**SUBMISSION TO PLANNING SCHEME AMENDMENT C69 (RE-EXHIBITED)**

**13 Gratton Street Port Fairy VIC 3284**

Figure 1 Exhibited Overlay Reedy Creek Environs between Princes Highway and Hamilton-Port Fairy Road with 13 Gratton Street highlights in blue

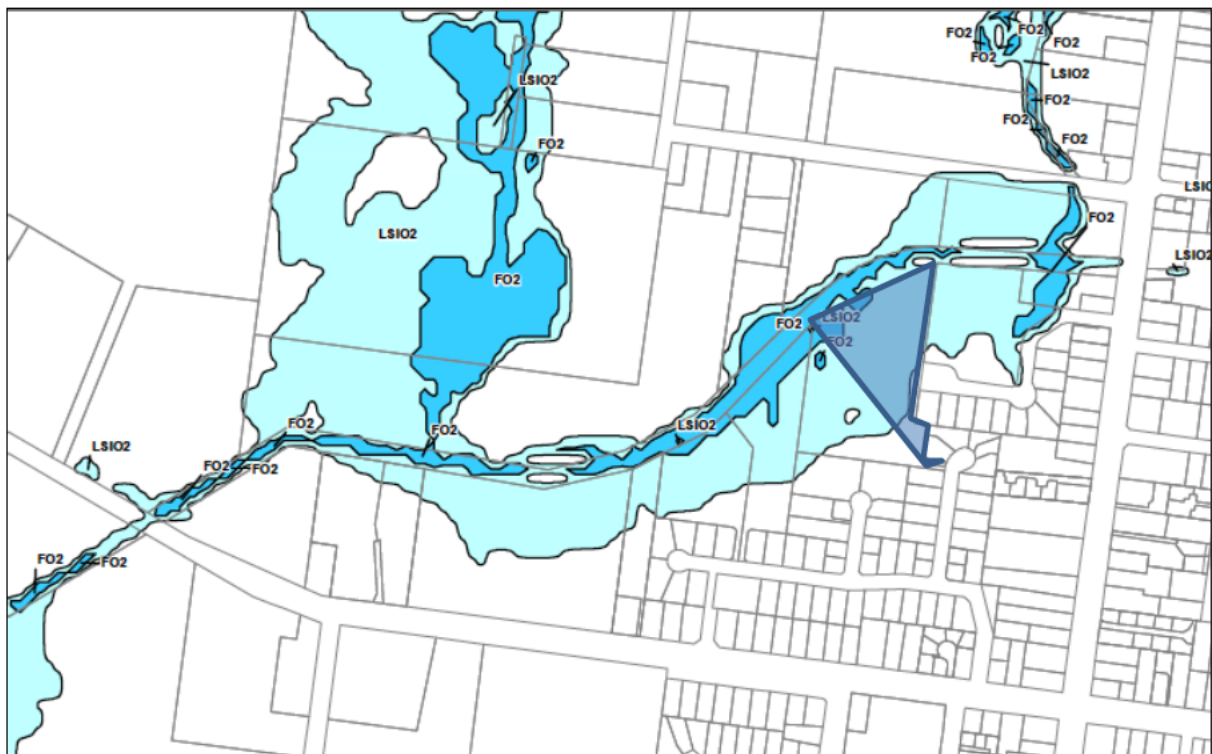
6. The proposed changes in the first exhibition of C69 proposed that the land would have a reduced flood extent and that the bulk of the land would be instead located in the Land Subject to Inundation Overlay.

7. On the basis of the information contained in the first exhibition, the landowner did not consider it was necessary to make a submission to C69 as the flood extent was being reduced on their land to an extent where the rear part of their land may in fact have been viable to subdivide the land to provide another vacant lot for future residential development with a frontage to Perry Close, with a concept building envelope located on the higher portion of the site.

Figure 2 2021 Modelling showing significant change in extent of FO proposed to Reedy Creek Environs between Princes Highway and Hamilton Port Fairy Road

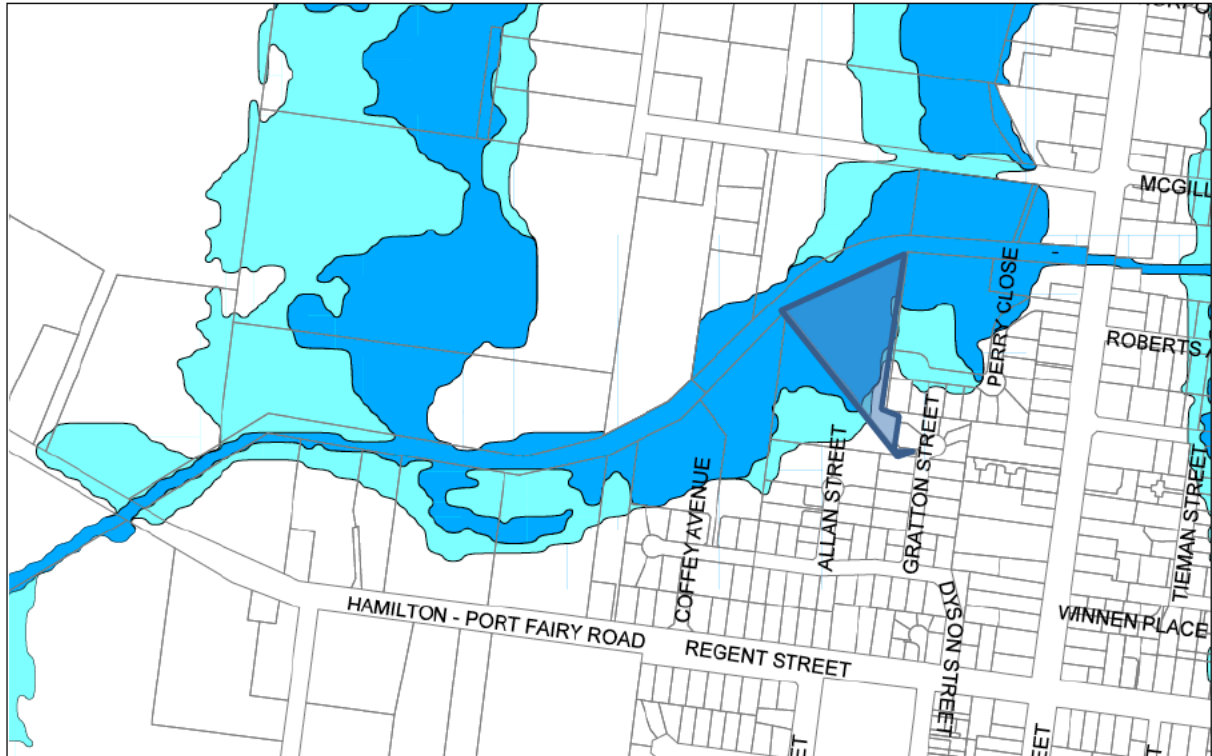
11. Now that the re-exhibition of the C69 is available, the land is now returned to being predominantly located in the Floodway Overlay and may not receive the support of the GHCMA to be able to be developed or subdivided in the future, despite the reduction in flood risk from the works undertaken to Reedy Creek.

12. The Flood Summary Report details that the Floodway Overlay has been applied to land where expected floodwater is expected to have a flood depth of greater than 0.5m and a velocity by depth of 0.4m per second or more.

13. When questions on this were posed to Council staff and HARC in December 2021, they indicated the GHCMA had revised the data point at which they recommend the LSIO or FO be applied (my understanding is it was to be reduced from 0.5m to 0.3m but I haven't been able to confirm this – and it wasn't mentioned by the flood experts) and despite the mitigation works undertaken in Reedy Creek desire the adjoining properties generally remain with the Flood Overlay.

Figure 4 Part A Mapping Showing 0.8m sea level rise conceptual controls

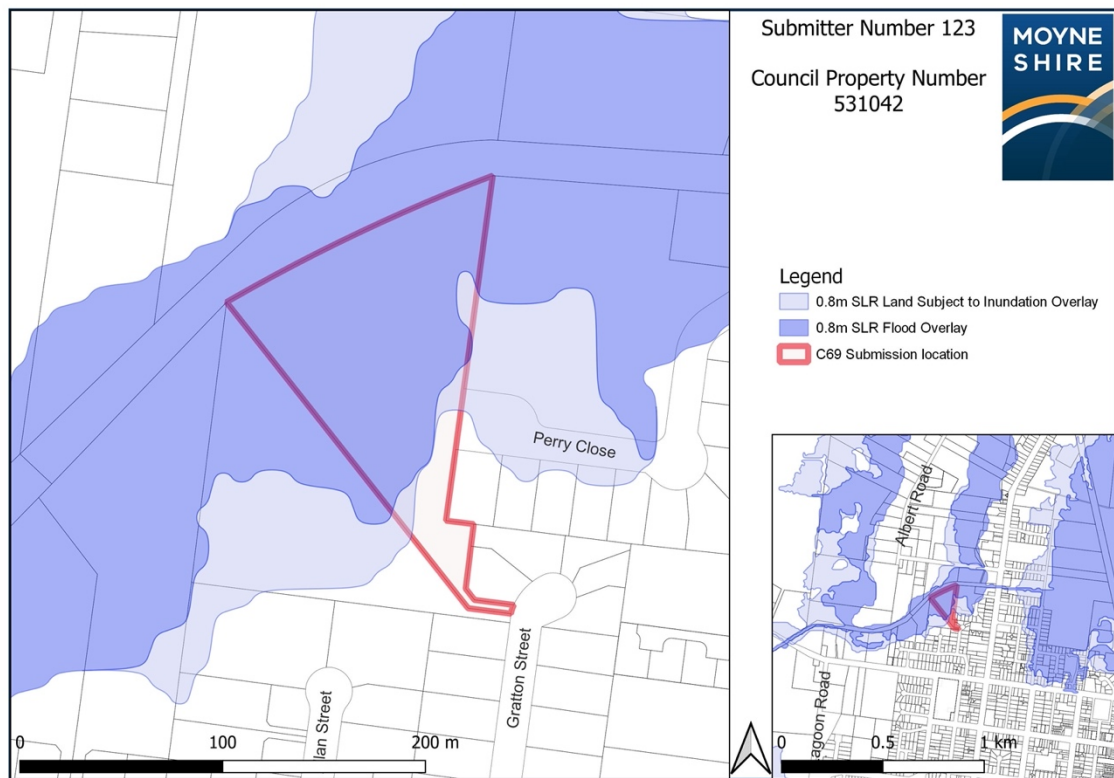
23. The 0.8m sea level rise mapping shows a reduction in extent of both FL and LSIO near the eastern boundary, which if supported may allow for a two lot subdivision and the construction of a dwelling on a new lot accessed from Perry Close without creating any additional flood risk.
